MEETING:	PLANNING AND REGULATORY COMMITTEE
DATE:	27 SEPTEMBER 2018
TITLE OF REPORT:	<p>182314 - SUMMARY DESCRIPTION (FOR FULL DESCRIPTION SEE APPLICATION FORM AND PLANNING CASE STATEMENT): • PROPOSED NEW FIELD ACCESSES • PROPOSED MAINTENANCE TRACKS TO SERVE SOUTHERN LINK ROAD (APPLICATION 151314) AT MULTIPLE PARCELS OF AGRICULTURAL LAND, SOUTHERN LINK ROAD CORRIDOR (151314) A465 - A49, HEREFORDSHIRE</p> <p>For: Mrs Lane per Mr Jiggins, WSP, The Victoria, 150-182 The Quays, Salford, Manchester, M50 3SP</p>
WEBSITE LINK:	https://www.herefordshire.gov.uk/info/200142/planning_services/planning_application_search/details?id=182314&search=182314
Reason Application submitted to Committee – Council owned land with objections

- 1.2 The applicants, Herefordshire Council, are seeking planning permission for ancillary works that lie outside the original application boundary. These proposals relate primarily to minor alterations; including the creation of new accesses (and field gates), alterations to property boundary (Pykeways) and alterations to drainage arrangements. The most notable piece of development required is the construction of a temporary haulage route. These proposals are describ

Sheet 1 - New field access and drainage ditch crossing (Site Plan – Sheet 1)

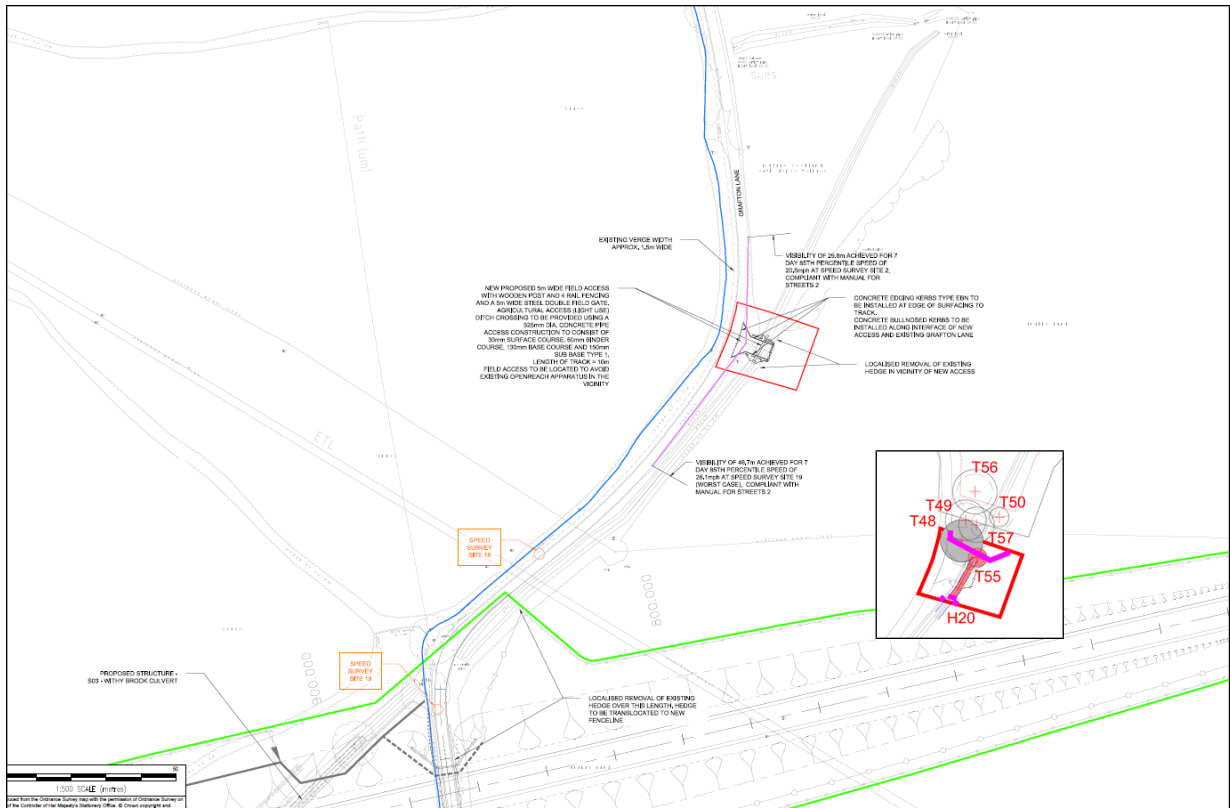
Site no.	Drawing no/ref	Location	Comments
1	Sheet 1	Grafton Lane	Access location is fine, conformation required on achievable distances required for conditions
2	sheet 2	Grafton Lane (adjacent to Wither Brook)	Is restricted by house wall, visibility splay distances need to be provided for conditions
3	Sheet 3		No vehicle access points
4	Sheet 4	Haywood Lane	Need speed data, significant hedge removal required. How much is in highway land or is owned by applicant/LA. Visibility splays are based on the signed speed limit not the actual 85th%tile.
5	Sheet 5	Haywood Lane	Need speed data, significant hedge removal required. How much is in highway lane or is owned by applicant/LA. Visibility splays are based on the signed speed limit not the actual 85th%tile. Bridge barriers appear to be restricting visibility splays
6	Sheet 6		No vehicle access points
7	Sheet 7	A465	No location shown of the advanced direction signs. Will the access be put in before the roundabout, if after RB speeds will be lower? Visibility splay distances need to be provided for conditions. Justify the speeds and visibility splays

Drawing no/ref	Location	Conditions	Comments from submitted drawings - August 2018
Drawing no. 3512983BP- WSP-ZO- XX-DR-T- 00001-P04 Sheet 1	Grafton Lane	This is now acceptable, please see conditions below	The table shown in the letter dated 15th August 2018 provides a statement to how the accesses are to be built to road construction, however the updated drawing submitted shows construction details which are not to HC road specification. The required specification can be conditioned as part of any approval. .
		CAB - 2.4 x 31.7M – NORTH, 2.4 x 48.2 – South CAE, CAD -5M CAS, CAZ	Visibility splays have now been provided with 85th%tile speeds. Due to the limited use of the access the visibility splays are now agreed.

Sheet 2 - Drainage works and maintenance track / access

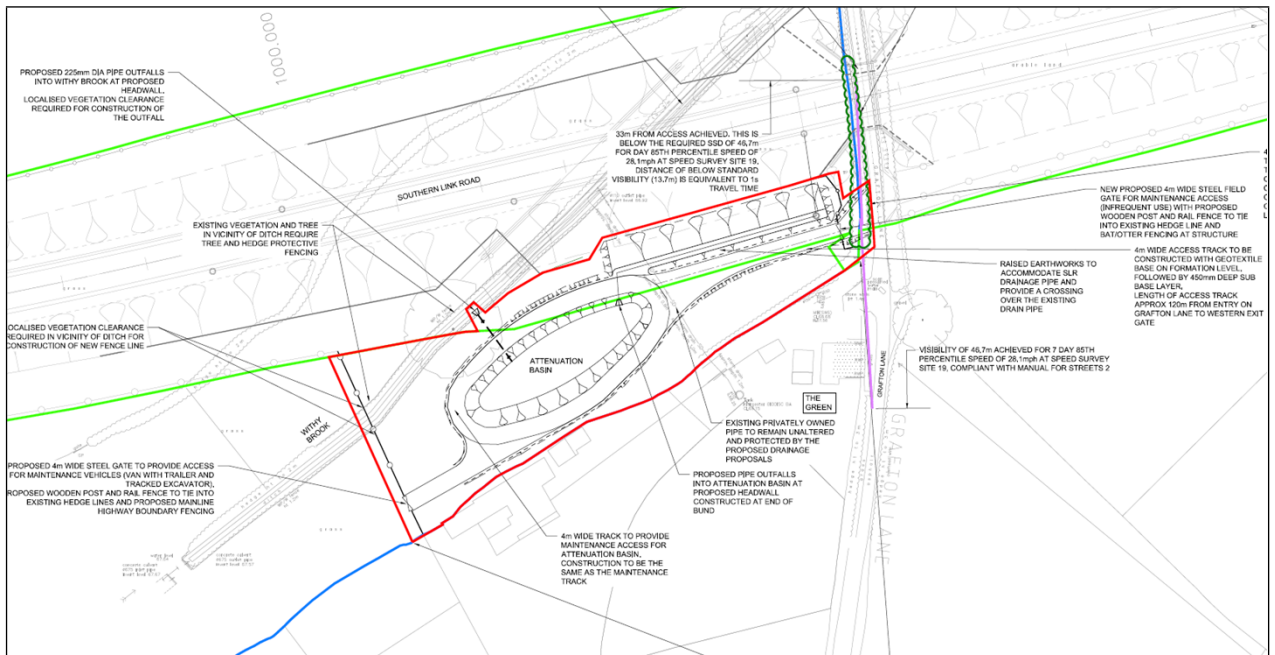
We have reviewed the information provided as part of application 182314 – in particular ‘Plan 2’ (attenuation basin and outfall to Withy Brook) and ‘Plan 6’ (3 outfalls into a ditch and enlarging and existing culvert from 2x150mm pipes to a 500mm pipe).

Drawing no. 3512983BP- WSP-ZO- XX-DR-T- 00002-P04 Sheet 2	Grafton Lane (adjacent to Withy Brook)	This is now acceptable, please see conditions below	The submitted documents state that a north visibility splay can only achieve 33m however as shown in Mfs2 visibility splays can measure to the running lane of the road, therefore can achieve a greater distance
		CAB - 2.4 x 31.7M – NORTH, 2.4 x 48.2 – South. CAE, CAD -5M CAS, CAZ	The table shown in the letter dated 15th August 2018 provides a statement to how the accesses are to be built to road construction, however the updated drawing submitted shows construction details which are not to HC road specification. The required specification can be conditioned as part of any approval. .
			Access has now been located within the red line.

Sheet 3 - Proposed temporary Haul Road and realignment of cycle route

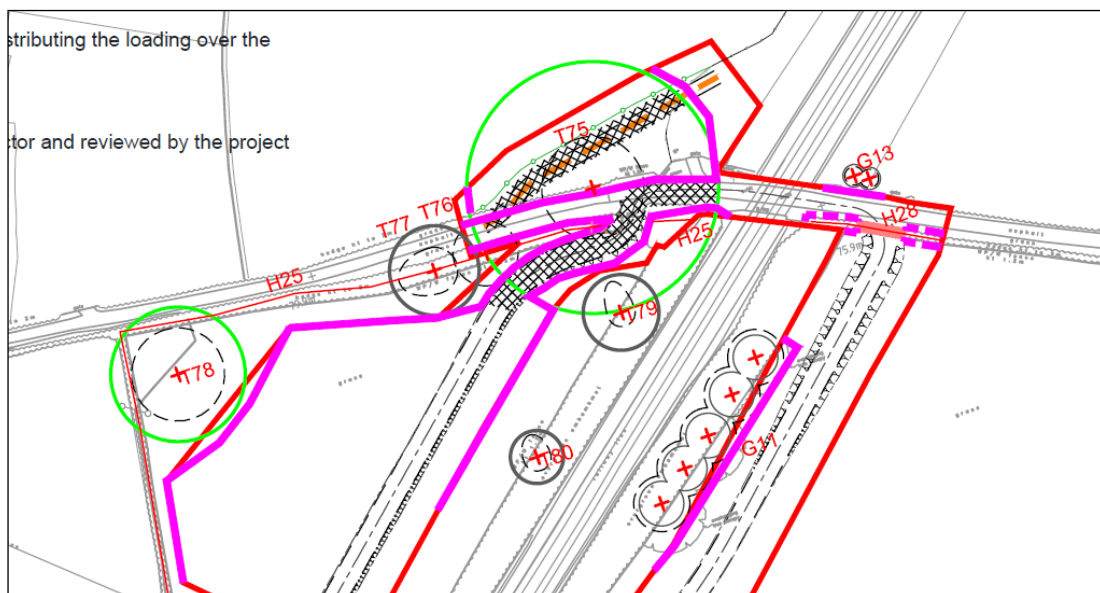
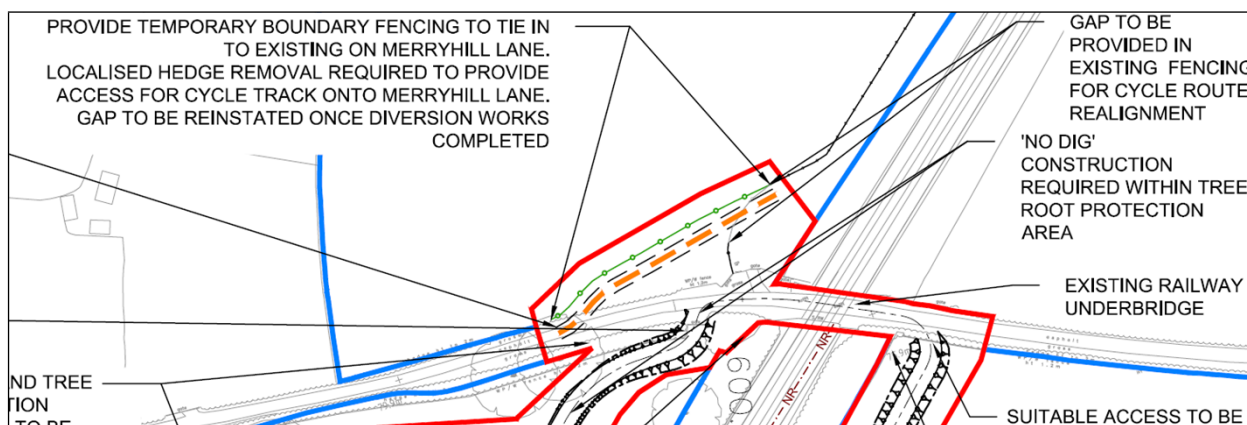
Proposed Site Plan Sheet 3 (3512983BP-WSP-Z0-XX-DR-T-00003): This plan identifies impacts on Public Footpath HA7, Byway Open to All Traffic GF7 (Merry Hill Lane) and Cycleway LCR82101 (Shaw's Path Cycleway). Temporary Traffic Regulation Orders will be required to effect closures of these routes during construction. I note the intention to provide

Sheet 3. The proposal is to alter the junction of the Cycleway and Merry Hill Lane, if travelling south along the cycleway, will users be able to turn eastwards to access Grafton Lane?

Sheet 4 – Access / Maintenance track off Haywood Lane

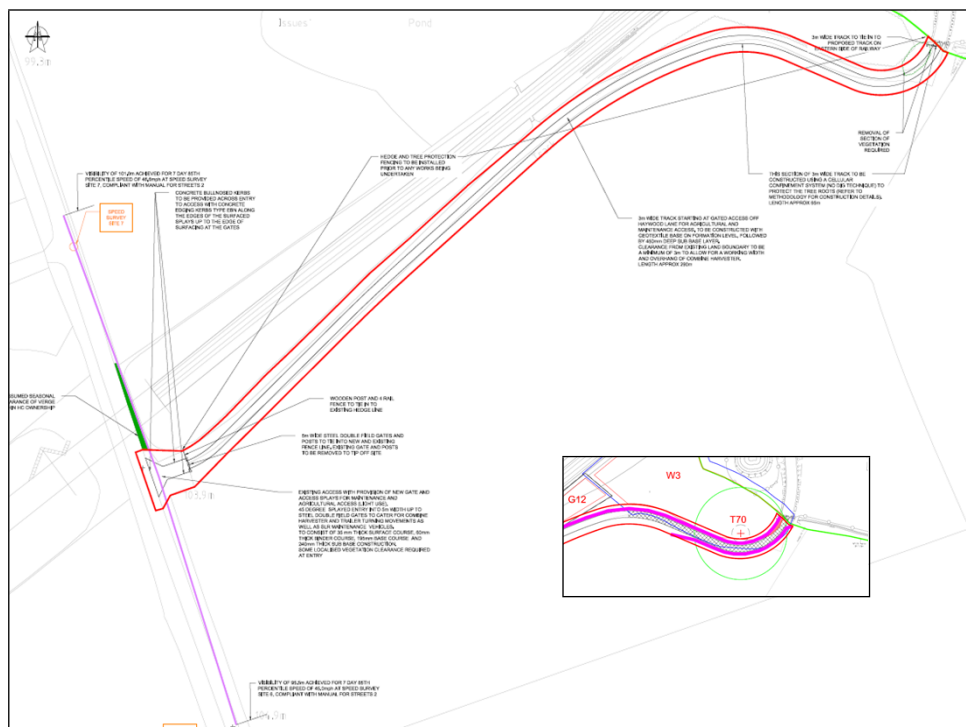
- The remedial works proposed in respect of the temporary haul road – these should be shown upon a landscape plan.
- The extent of proposed woodland removal for the construction of a maintenance track as shown on sheet 4 of the plans.
- The extent of hedgerow removal for the provision of self closing gates and adequate visibility at the entrance to the bridleway as shown in plan 8.
- The full extent of hedgerow removal to provide field access gates and visibility splays proposed within drawings on sheets; 1,4,5,7,8 and 10

- Sheet 4: entry to permanent maintenance track via access south of railway bridge: it is questioned why such a wide access (5m wide double steel gates, which exceeds existing access, which suffices for combine harvesters). Additional to the industrial appearance of the gates, the concrete curbs generate an urban image in this rural location. We have some concern that any damage to the woodland landscape should be avoided.

<p>Drawing no. 3512983BP- WSP-ZO- XX-DR-T- 00004-P04 Sheet 4</p>	<p>Haywood Lane</p>	<p>This is now acceptable, please see conditions below</p>	<p>After revisiting the site to look at the issue of vegetation around the visibility splay, there are still concerns regarding the vegetation to the north of the access restricting the visibility splay. The visibility splay should be cut back to provide improvements to the current visibility splay however It is noted that it's an existing access and has very limited current use which won't significantly increase with the proposals. A traffic management plan and construction management must be conditioned as this may be used as an alternative haul road to the construction site and therefore significantly increase vehicles from a substandard access. Visibility splays have now been provided with 85th%tile speeds.</p>
		<p>CAB - 2.4 x 101M – NORTH, 2.4 x 95.5m – South, CAE, CAD -5M CAS, CAZ. Construction management plan for Haul Road</p>	<p>The table shown in the letter dated 15th August 2018 provides a statement to how the accesses are to be built to road construction, however the updated drawing submitted shows construction details which are not to HC road specification. The required specification can be conditioned as part of any approval. .</p>

Sheet 5 – New Field Access (Haywood Lane), drainage ditch crossing (hedge removal and new hedge planting)

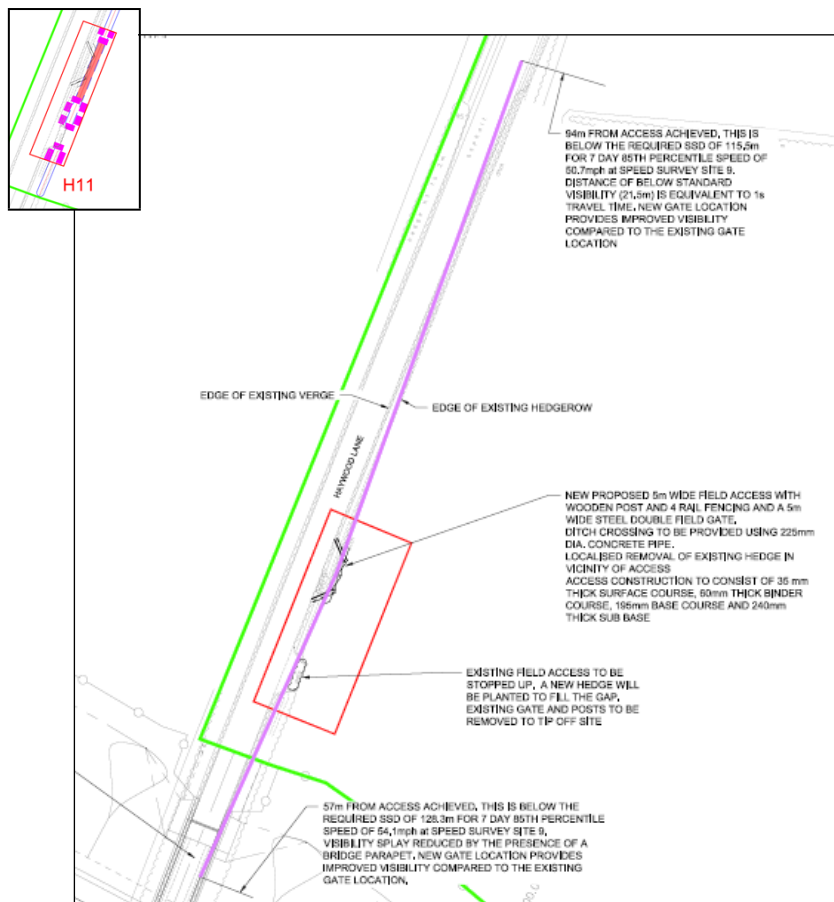
- Sheet 5: again the 5 m wide double steel gates gives an industrialised image not suitable for a rural setting.
- Sheet 9: more explanation is needed as to the purpose of the installation of a new bridle way. This is not an objection but required for clarity.

<p>On the notes and drawings shows the following statement "Assumed seasonal clearance of verges with HC ownership" This will be classed as highway land and come under the associated actions as all highway land.</p>
<p>Drawing no. 3512983BP- WSP-ZO- XX-DR-T- 00005-P04 Sheet 5</p>	<p>Haywood Lane</p>	<p>This is now acceptable, please see conditions below</p>	<p>Visibility splays have now been provided with 85th%tile speeds. Due to the limited use of the access, the types of vehicles which will use the access and the verge width in front of the site the visibility splays are now agreed.</p>
		<p>CAB - 2.4 x 94M – NORTH, 2.4 x 57m – South. CAE, CAD -5M CAS, CAZ</p>	<p>On the notes and drawings shows the following statement "Assumed seasonal clearance of verges with HC ownership" This will be classed as highway land and come under the associated actions as all highway land.</p>

Sheet 6 – Drainage works – site to the south west of Hayleasow Wood.

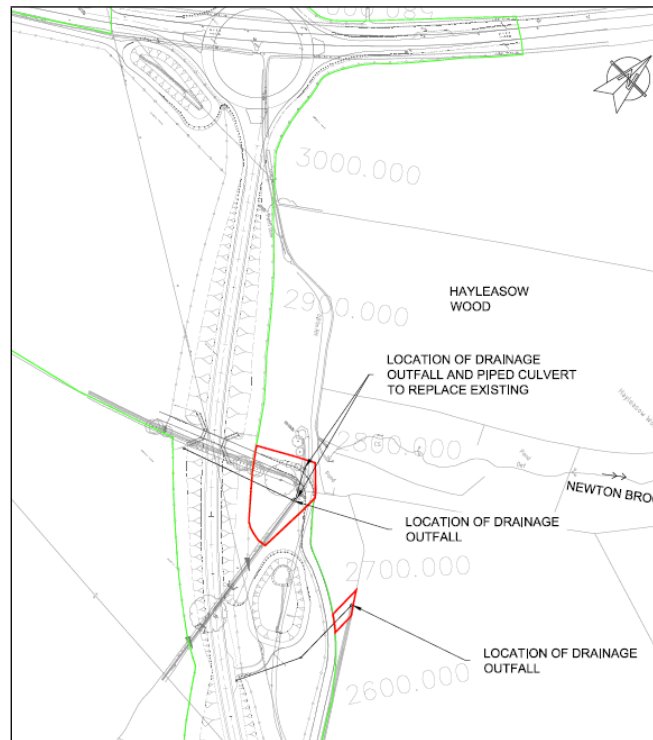
Proposed Site Plan 6 (3512983BP-WSP-Z0-XX-DR-T-00006): No new impacts on Public Footpath HA3 and its proposed diversion are identified. No further comments.

- 6.45 A number of representations refer to the potential impacts of the development on Ancient Woodland (specifically Hayleasow Wood) due to the proximity of the application site as detailed on Sheet 6. These works relate to the provision of new drainage outfall pipes.

Drawing no. 3512983BP- WSP-ZO- XX-DR-T- 00006-P04 Sheet 6			No comments, No vehicle access points
Drawing no. 3512983BP- WSP-ZO- XX-DR-T- 00007-P04 Sheet 7	A465	This is now acceptable, please see conditions below	Visibility splays have now been provided with 85th%tile speeds. Due to the limited use of the access the visibility splays are now agreed.
		CAB - 2.4 x 139.3M – NORTH, 2.4 x 156.1– South. CAE, CAD -5M CAS, CAZ	The table shown in the letter dated 15th August 2018 provides a statement to how the accesses are to be built to road construction, however the updated drawing submitted shows construction details which are not to HC road specification. The required specification can be conditioned as part of any approval.

Sheet 8 – Proposed changes to highway at Pykeways and proposed accesses on the B4349

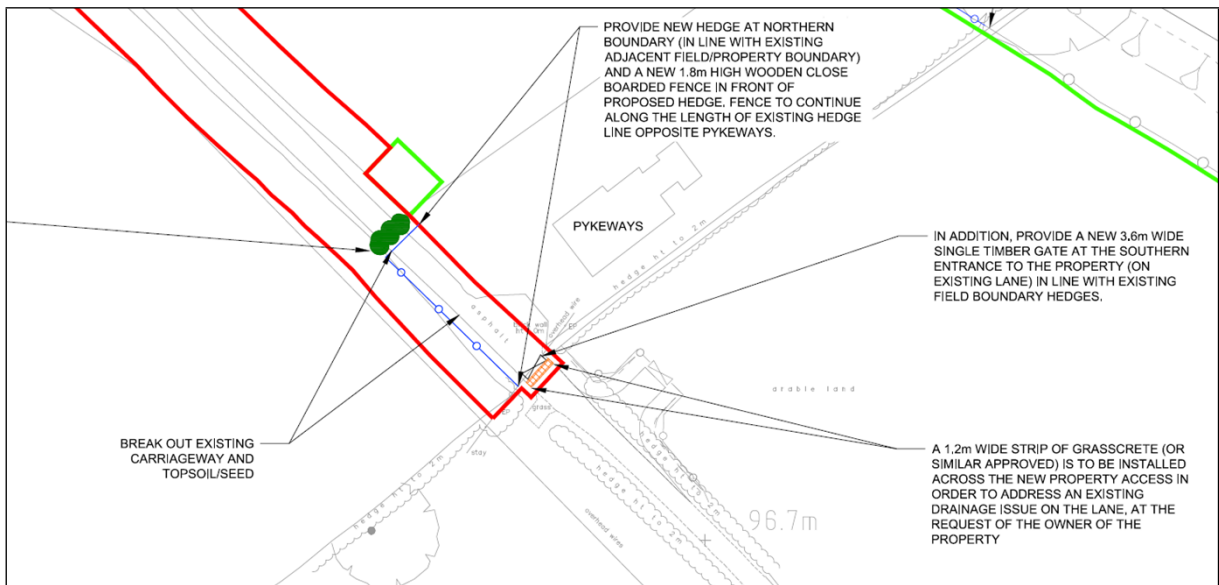
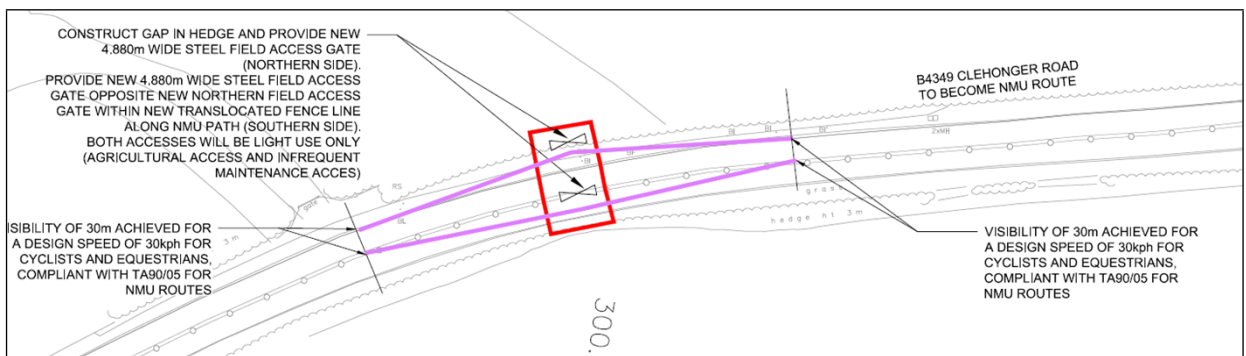
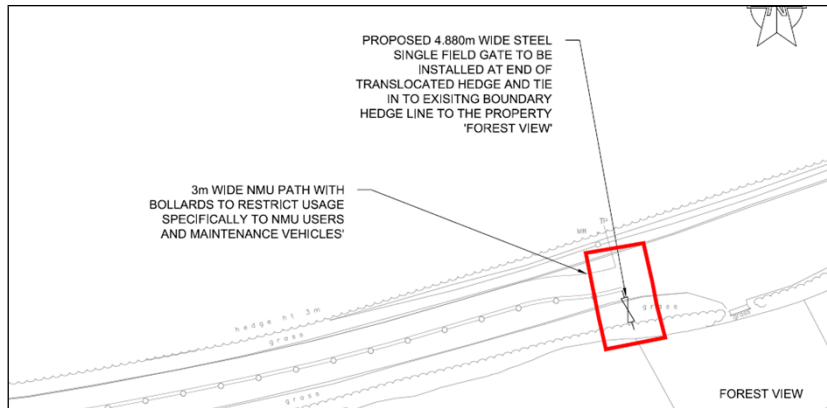
8	Sheet 8	B4349	Further details should be provided in regards to the access on the new road (with visibility splays) . What type of access will be provided for this stretch of road e.g. access only? Will the road be narrowed? Large removal of hedgerow to meet visibility splays on the southern side. Clehonger court side - previous accidents cluster site. A turning head is required especially for people who go there by mistake. Issues with location of access and bend signs.
9	Sheet 9	Grafton Lane	Visibility splay distances need to be provided for sites for conditions. The requirement about of hedgerow which needs to be removed needs to be shown. (both accesses) the visibility splays need to be supported by speed data
10	Sheet 10	Off the B4349	Location of gates could be problematic for long vehicles exiting the field, therefore at the junction the vehicle would not be 90 degrees to the carriageway/junction, visibility splay distances need to be provided for conditions.

Drawing no. 3512983BP- WSP-ZO- XX-DR-T- 00008-P04 Sheet 8	B4349	This is now acceptable, please see conditions below CAB - 2.4 x 30m, CAE, CAD -5M CAS, CAZ	It should be noted that the concerns regarding the lack of a turning head for service/waste vehicles are still concerns. Even with the proposed closure of the road to motor vehicles, the road will still service 14 dwellings. This section is not subject to this current planning application; however discussion with the design team should be undertaken to remove this safety concern in designing the NMU area. The turning head discussions should also be undertaken regarding Pykeways. Discussions regarding the ownerships of land if there are two hedgerows and location of Statutory Undertakers equipment should also be discussed with the design team

Sheet 9 – Creation of bridleway and installation of new gates – Grafton Lane

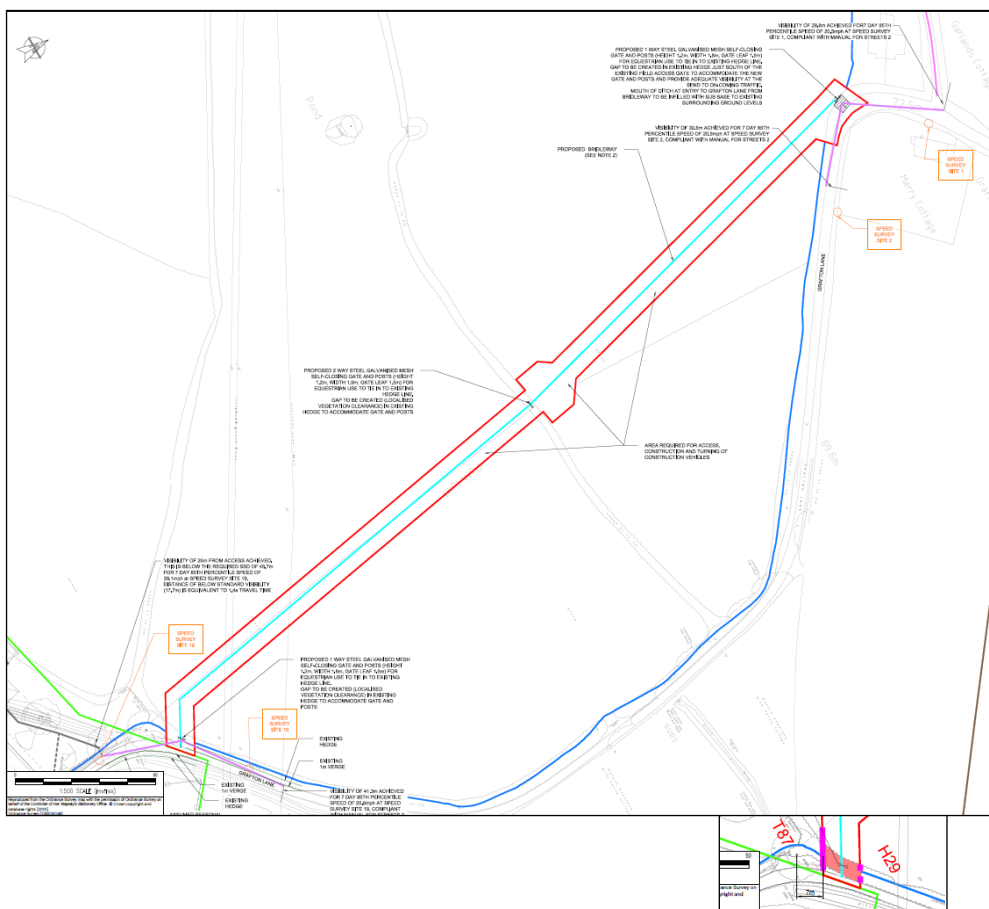
Care will be needed as regards the "new bridleway" indicated on *Sheet 9* south of Grafton. This bridleway crosses a non designated heritage asset of interest, a motte in enclosure site (HER ref 10467).

Proposed Site Plan Sheet 9 (3512983BP-WSP-Z0-XX-DR-T-00009): This plan identifies the installation of three bridle gates on the proposed bridleway running between two points on Grafton Lane. It also identifies the need for appropriate signage at each terminal point. I agree that the two gates situated at the terminal points on Grafton Lane should be one-way opening and the intermediate gate, 2-way. Please note that the gates should comply with British Standard BS5709:2018 including requirements for set-back distance and manoeuvring space.

Sheet 9 – There provision of the new bridleway is very welcome but will it be a permanent dedication or just a temporary expedient whilst construction works are taking place?

Drawing no. 3512983BP- WSP-ZO- XX-DR-T- 00009-P04 Sheet 9	Grafton Lane	This is now acceptable, please see conditions below	Visibility splays have now been provided with 85th%tile speeds. Due to the limited use of the access the visibility splays are now agreed. The south access - southern direction could benefit with moving the gate further west to increase the visibility splays. The current layout of the road has a large area which users of the bridleway will naturally head towards to increase the visibility on the highway verge, therefore the visibility splays are agreed.
		NORTH ACCESS CAB - 2.4 x 31.7M – NORTH, 2.4 x 62.5– South, CAE, CAD -5M CAS, CAZ	
		SOUTH ACCESS - CAB - 2.4 x 42.9M – NORTH, 2.4 x 29M– South, CAE, CAD -5M CAS, CAZ	The table shown in the letter dated 15th August 2018 provides a statement to how the accesses are to be built to road construction, however the updated drawing submitted shows construction details which are not to HC road specification. The required specification can be conditioned as part of any approval.
